## Defective 3" Fuel Cap

**Subject:** Defective 3" fuel caps for EPA/CARB compliant tanks

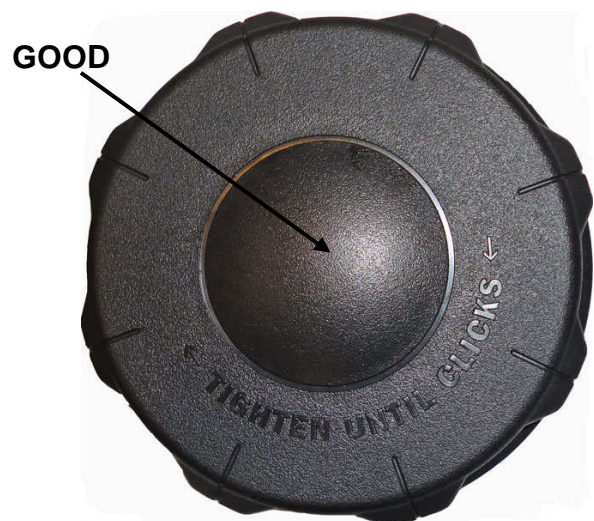
**Situation:** Wright received 170 defective 3" fuel caps from our vendor. (See below photo for defective cap) The defective cap does not tighten properly and may allow a small amount of fuel to leak.

**Defective Cap** – Has fuel pump and text "Unleaded Gasoline Only" on dome

**Good Cap** – Has smooth dome with zero diagram or text

**The Fix:** Inspect unit(s) for current cap. Replace defective cap if necessary. The below photo illustrates both the defective cap and the proper cap. Replacement caps can be ordered thru your distributor. (PN45410002)
